A G E N D A
FARRAGUT MUNICIPAL PLANNING COMMISSION

April 18, 2013
7:00 p.m. Farragut Town Hall

REPORT TO THE FARRAGUT MUNICIPAL PLANNING COMMISSION

SUBJECT: Staff comments on amendment to site plan for revised swimming pool at The Cottages at Pryse Farms, 744 Pryse Farms Boulevard, Farragut

SUBJECT: Discussion and public hearing on a final plat for Clarity Pointe Court, Parcel 37.04, Tax Map 153, located on the west side of Concord Road approximately 1,300 feet north of Northshore Drive, Zoned C-1, 12.31 Acres (Tom Schaffler, Jr., Applicant)

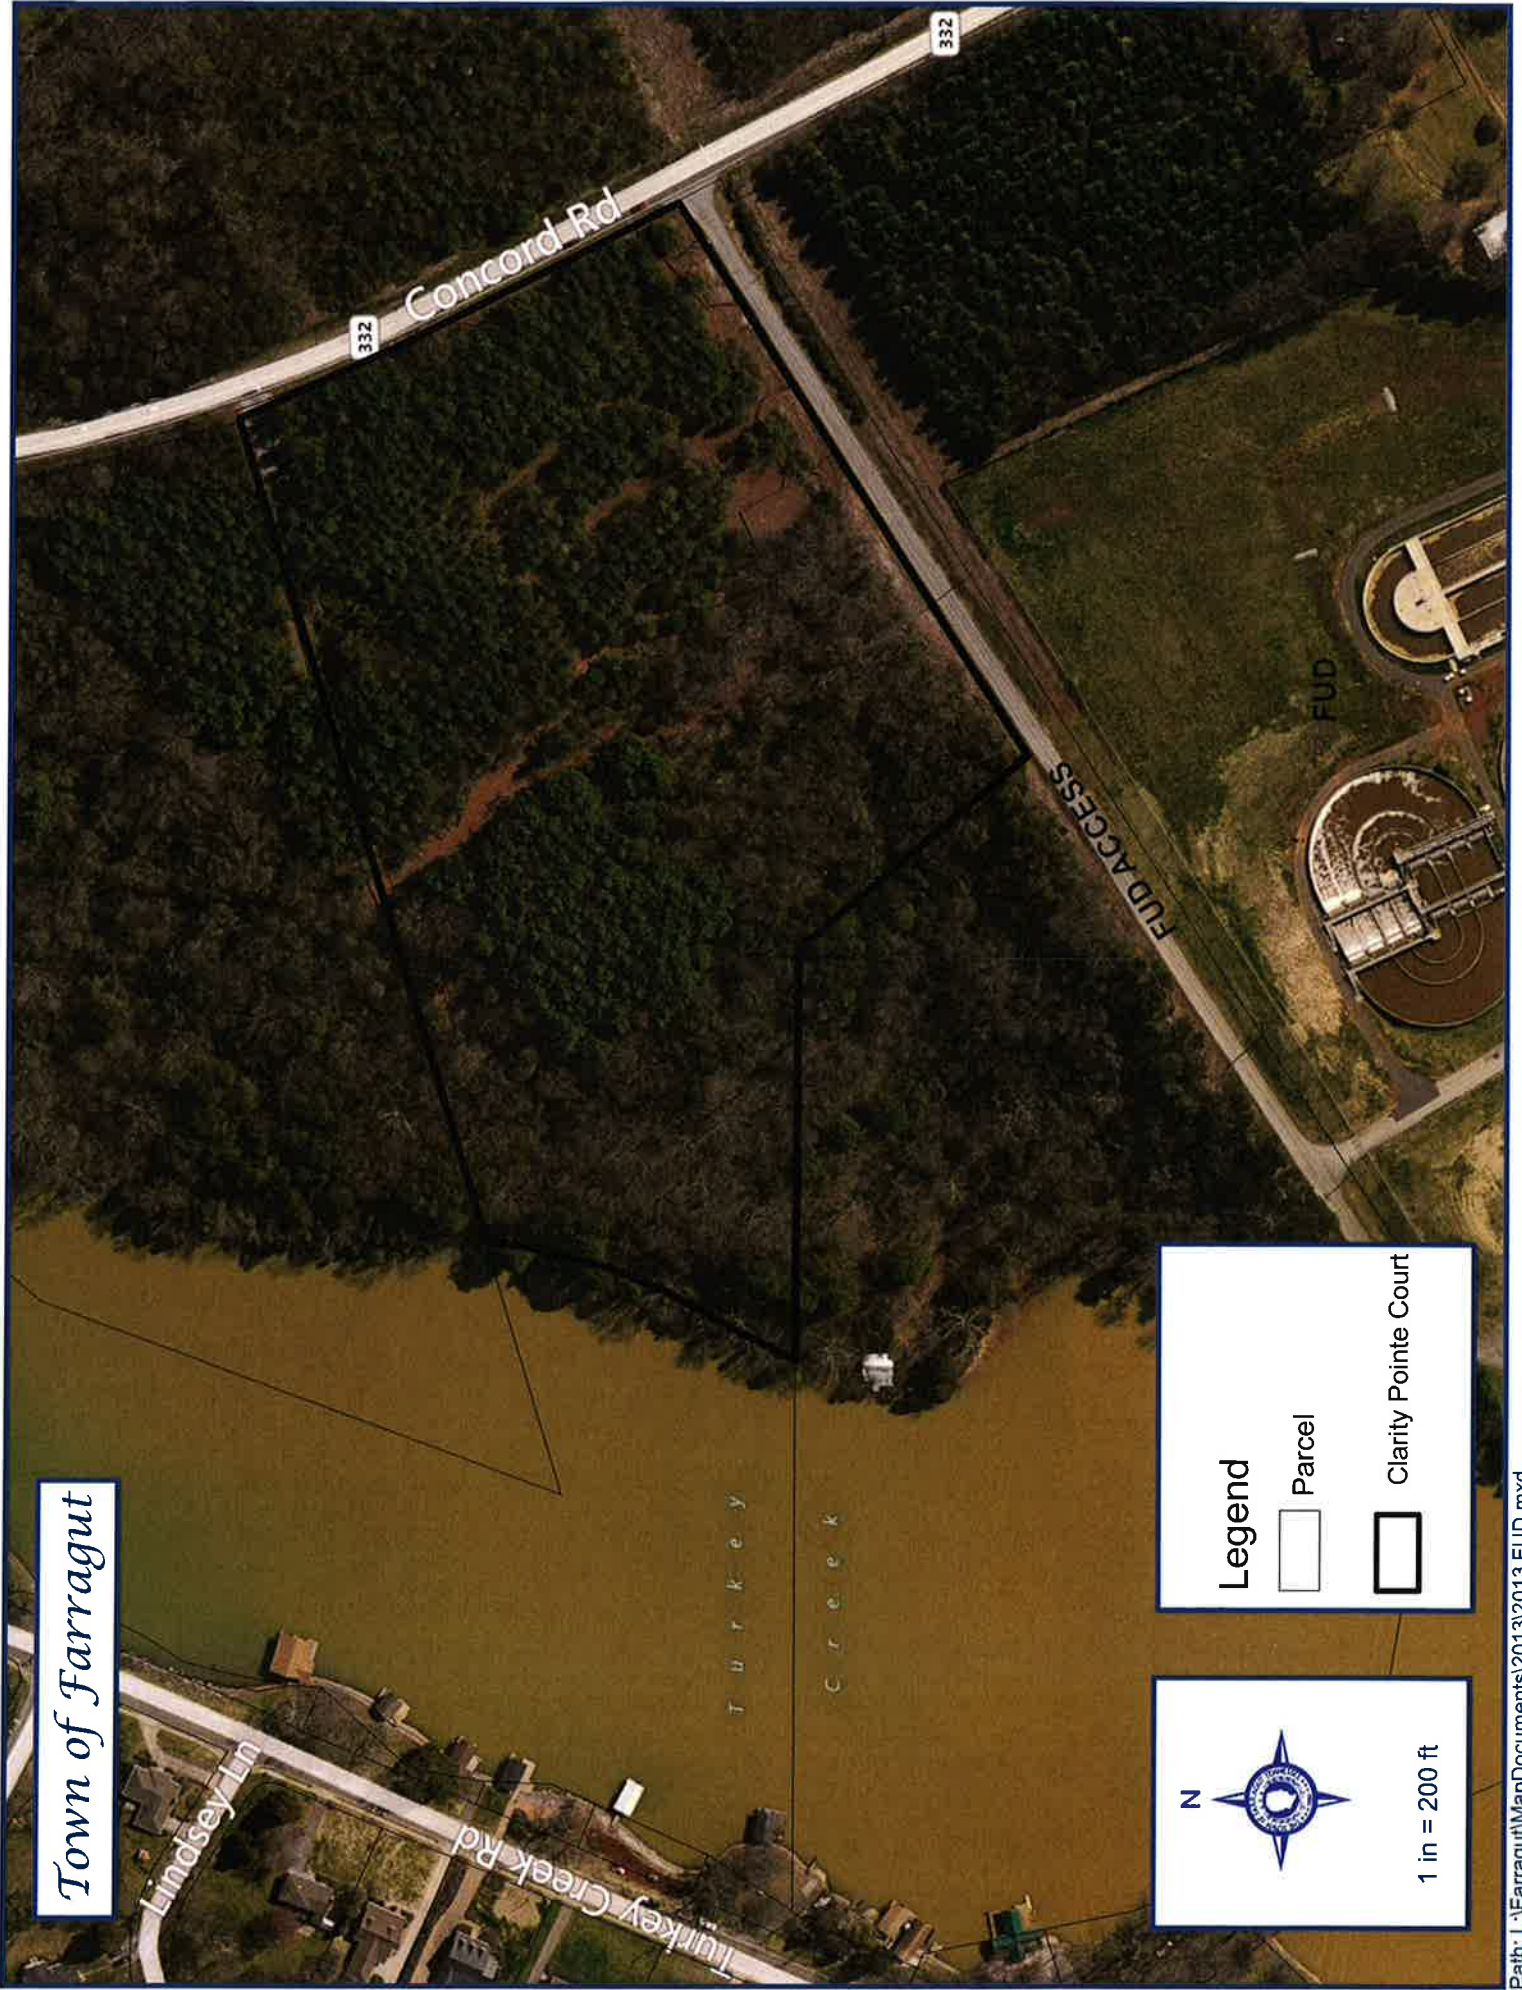
1. Delete as-built information, unless it is an easement. For example, utility lines located within the right-of-way do not need to be shown and only the building and utility and drainage easements need to be shown on Lot 1;
2. Add the property owner information, including a person's name, as a numbered plat note;
3. On the map portion of the plat, indicate the street name on the street;
4. Indicate the width of Clarity Point Court at several locations, including the cul-de-sac;
5. Label the centerline of Concord Road;
6. Indicate the width from the property line to the centerline of Concord Road;
7. In a plat note, state the allowed uses on the open space (walking trails) and who is to own and maintain the open space;
8. Plat note # 1 - delete the words "Utility & Drainage Easements" above the note;

9. The walking trail is to be centered on a 20' easement, 10' each side of centerline. The centerline of the trail must be indicated with distance and bearing information included. Consider doing an enlarged diagram of this area. Delete plat note #11;

10. Add a plat note which reads "The walking trail is located within a twenty (20) foot greenway/walking trail easement. This twenty (20) foot greenway/walking trail easement shall be in favor of the Town of Farragut and reserved for public use. The Town of Farragut shall accept maintenance and liability of use of said easement;

11. Show all easements and include distance and bearing information. Plat notes #5 & 6 indicate not all easements are shown;
12. Show the portion of land subject to flood, the limit of the Base Flood Elevation (floodway, 100 and 500 year flood fringe boundaries, and 50% no fill line);

15. In the Cert. Of Ownership & Dedication, delete the words "Farragut Subdivision Regulations 26";
16. Delete the Cert. Of Common Areas Dedication;
17. Delete the Cert. Of Water and Sewer Availability and use the Cert. Of Approval of Water System and Cert. Of Approval of Sewer System;

18. Delete the Cert. Of Bonding for Required Improvements;
19. Provide adequate room for signatures on all the signature lines of the certifications;
20. The city control points that are referenced, are they of the Town of Farragut's grid system or the City of Knoxville's?

21. As drawing is very small on the plat, a great deal of unnecessary information should be eliminated to provide legibility;
22. Please complete all remaining items on Staff's site punchlist;
23. Please submit 2-year Maintenance letter of credit for maintenance of roadway, sidewalks and drainage structures in the amount of \$8600; and
24. TDOT has inspected the deceleration lane and entrance onto Concord Road, and issued a release.

Construction - Layout & Grading Plan

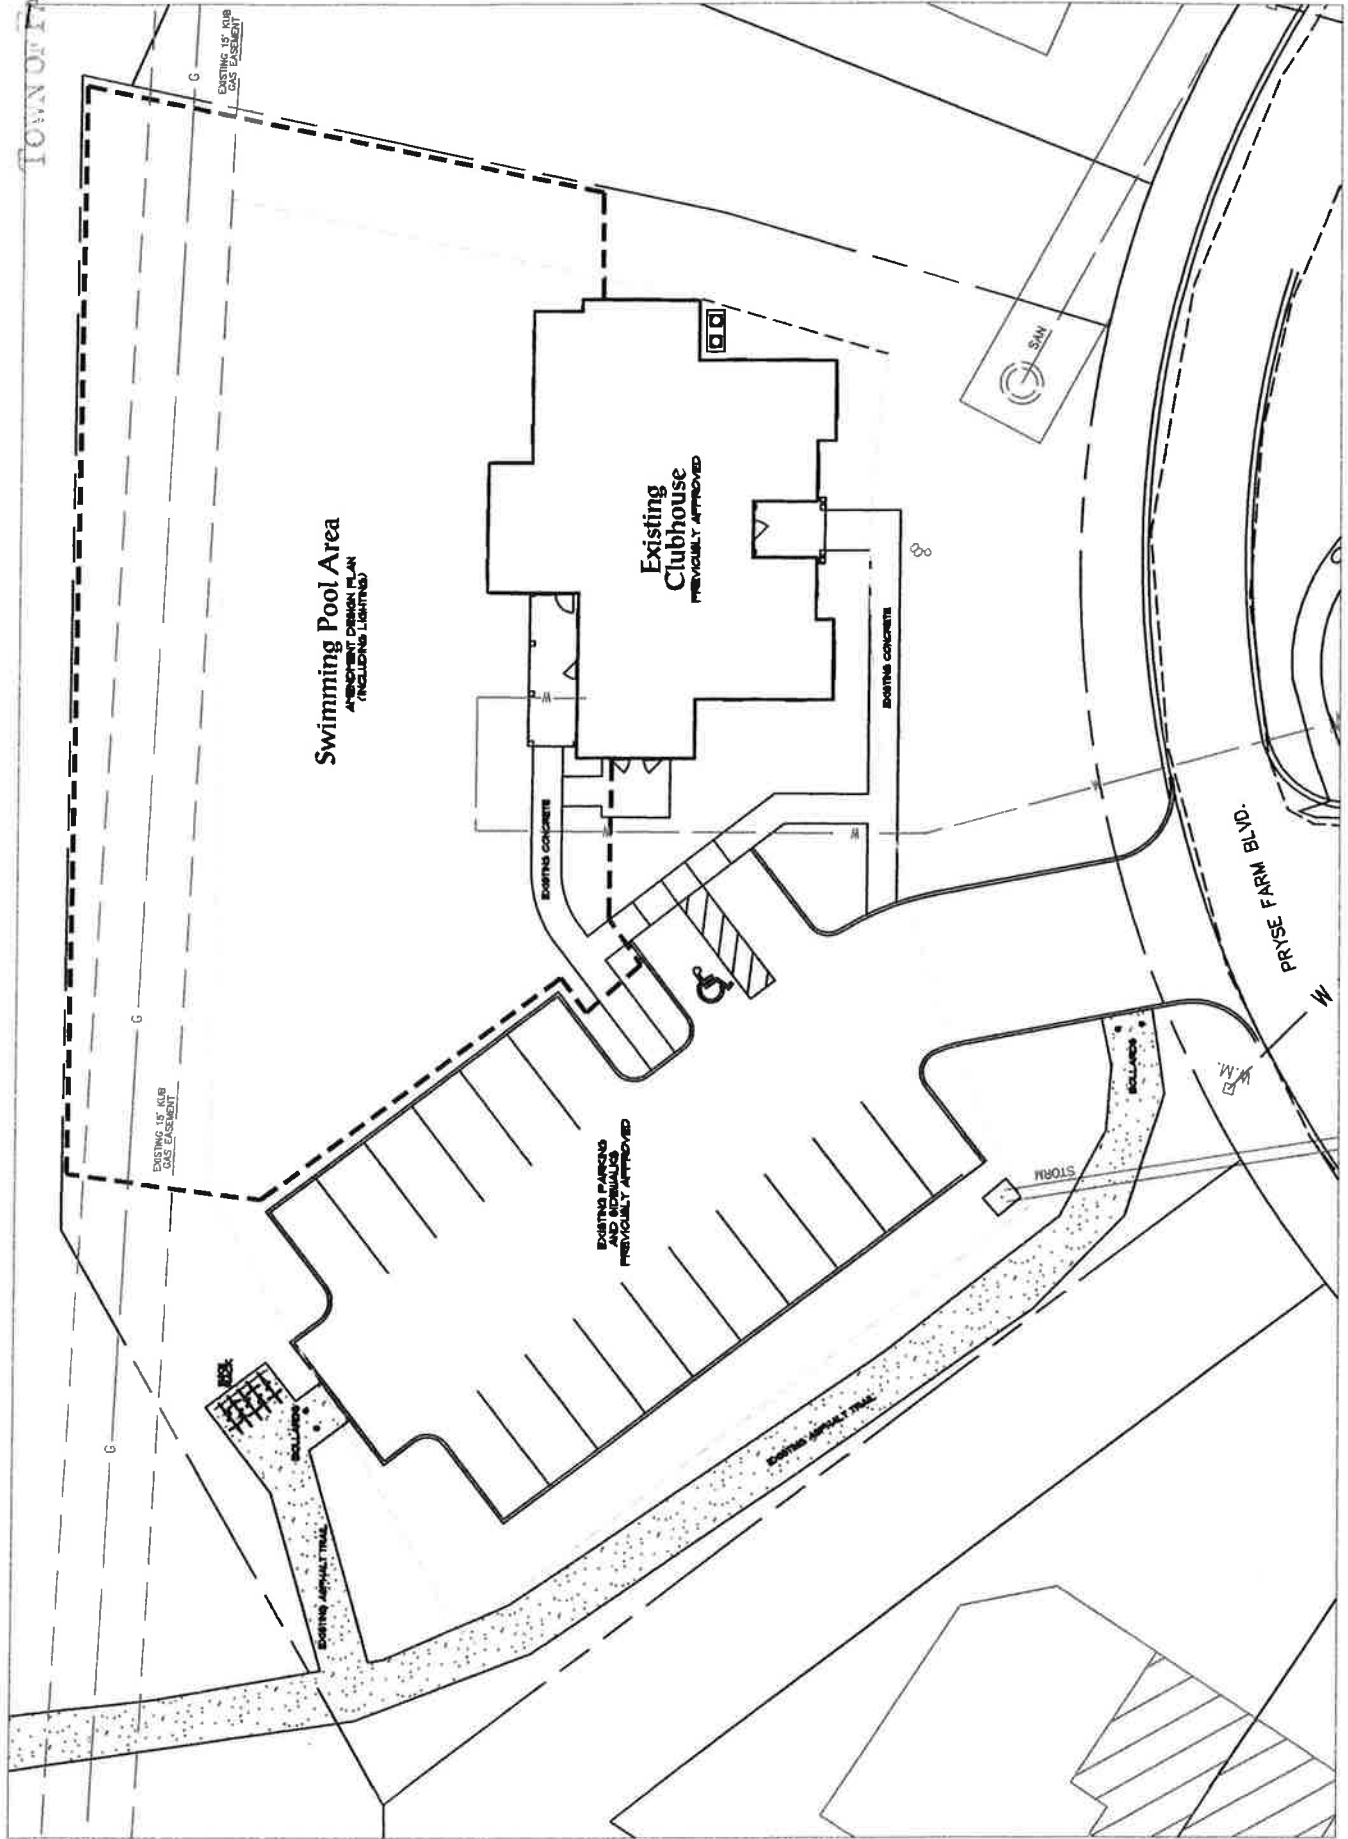
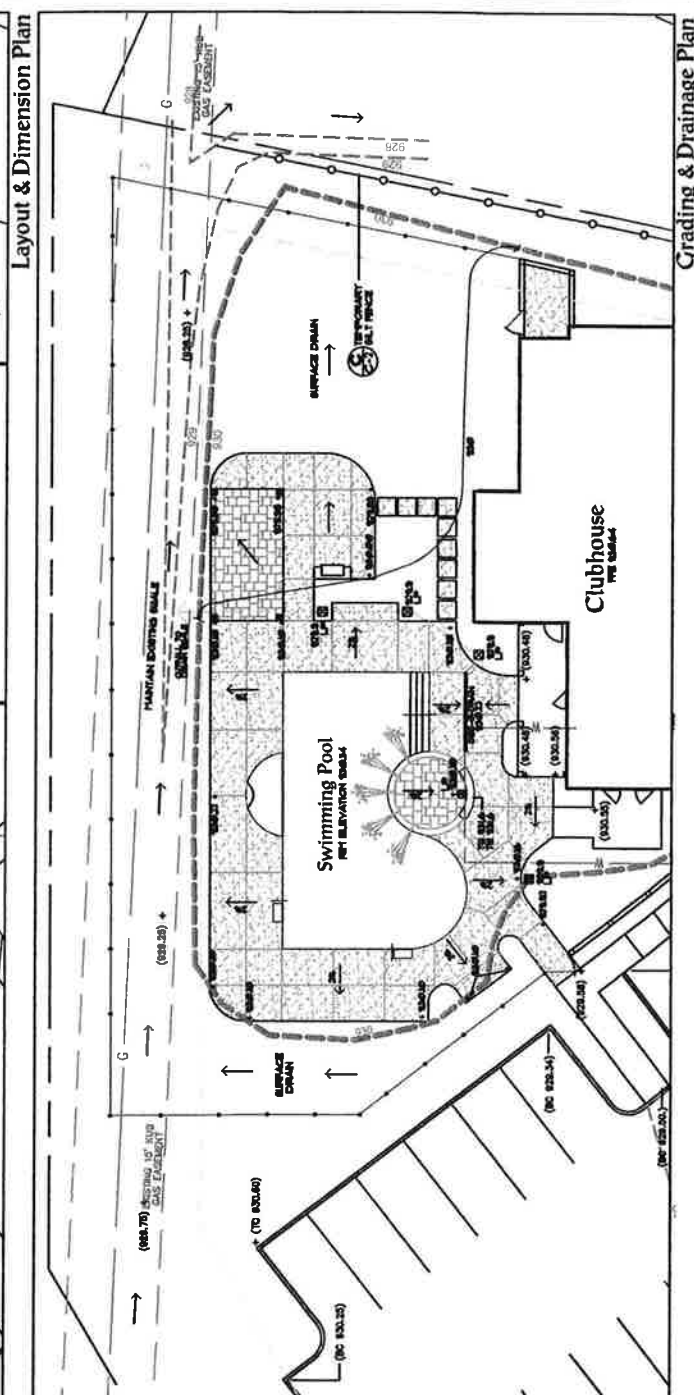
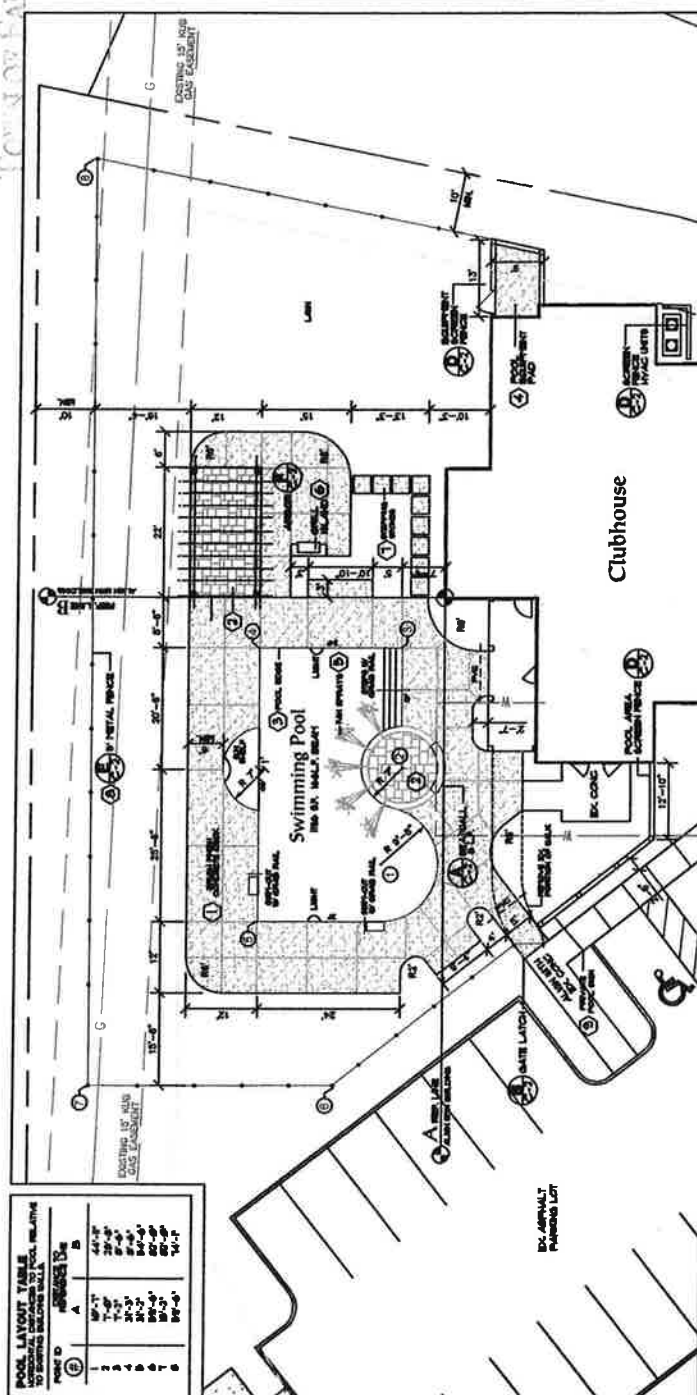
2. Recommend that the designer verify accessibility requirements are being met. A.D.A., which the town does not enforce, has new pool access requirements;

3. Include a person's name with the owner/developer information;
4. On the cover sheet, include the bike parking requirements for the site;
5. Include the bike rack(s) on the overall drawing;
6. Include the trail bollards on the overall drawing;
7. What is the pool layout table referencing?
8. Include a detail of the pool fence;

9. A note indicates a rain garden adjacent to the pool. There is a gas line in that location. Given the extensive work and expense of a rain garden, should it be constructed on a gas line?
10. You will need to get a building permit for the arbor;
11. Prior to the issuance of any Certificate of Occupancy, please submit a pdf of the finalized stamped approved site plans;

12. A two-year landscape maintenance Letter of Credit will be required before a Certificate of Occupancy will be issued;
13. The rain garden needs to also be part of the site plan submittal. The landscape plan will be reviewed separately;

14. How deep is the gas line where the rain garden feature is proposed? Though I like the idea of a rain garden I am concerned with so much plant material within a known utility easement. A significant amount of plant material would be impacted should any work be needed within the gas line easement;

16. The gas line easement on the site plan does not match what is shown on the final plat;
17. Is silt fencing acceptable perpendicular to the drainage swale? and

18. In the area outside the amended area please show what was approved on the previously approved plan.

4 NORTH ELEVATION
SCALE: 1/8"=1'-0"

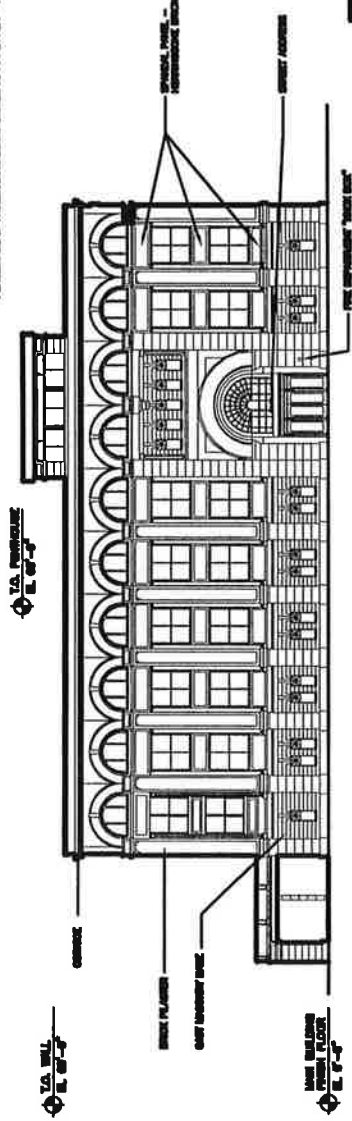
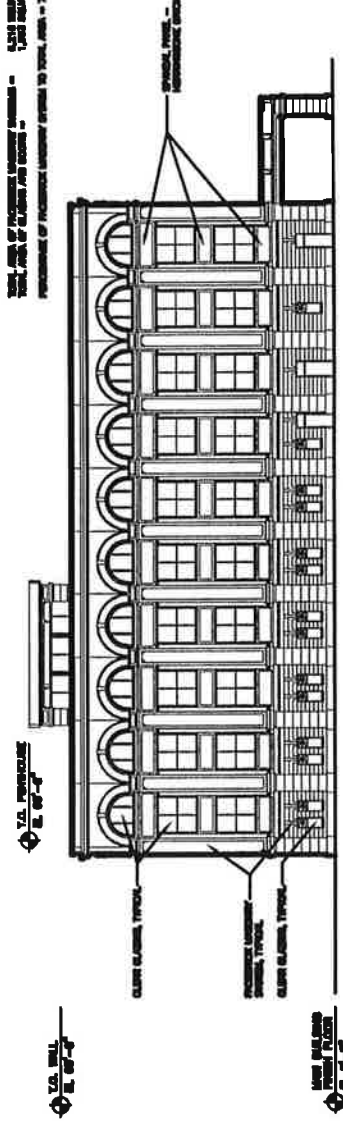
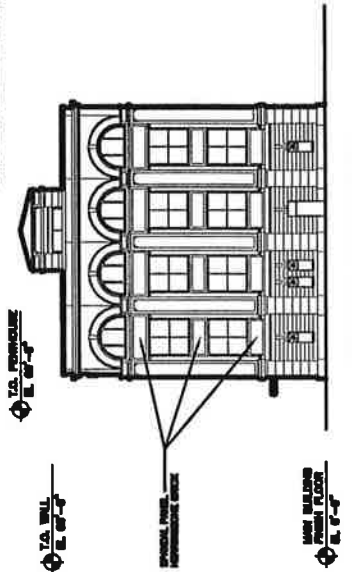
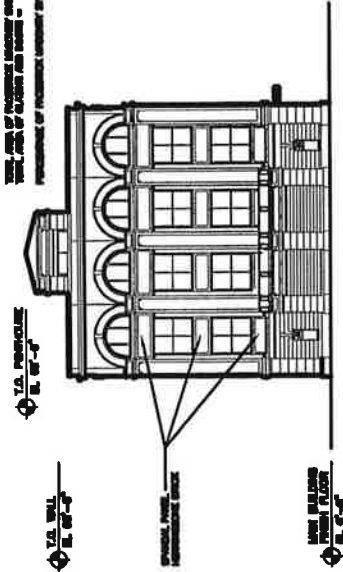
4. All sheets must be stamped and signed;
5. Sheet C0 - HVAC screening note - please use the wording from our ordinance;
6. Will all the HVAC units be housed in the penthouse?
7. Sheet A-2.0 - note "Brick parapet of sufficient height to screen HVAC equipment".
Provide line of sight drawings from adjacent properties and rights-of-way;

10. Sheet A-3.0 - the dumpster enclosure must use the same face brick as the building. Modify detail accordingly;
11. Sheet A-3.0 - the doors on the dumpster enclosure must be solid (100% opaque) vs. 90%). Modify detail accordingly;
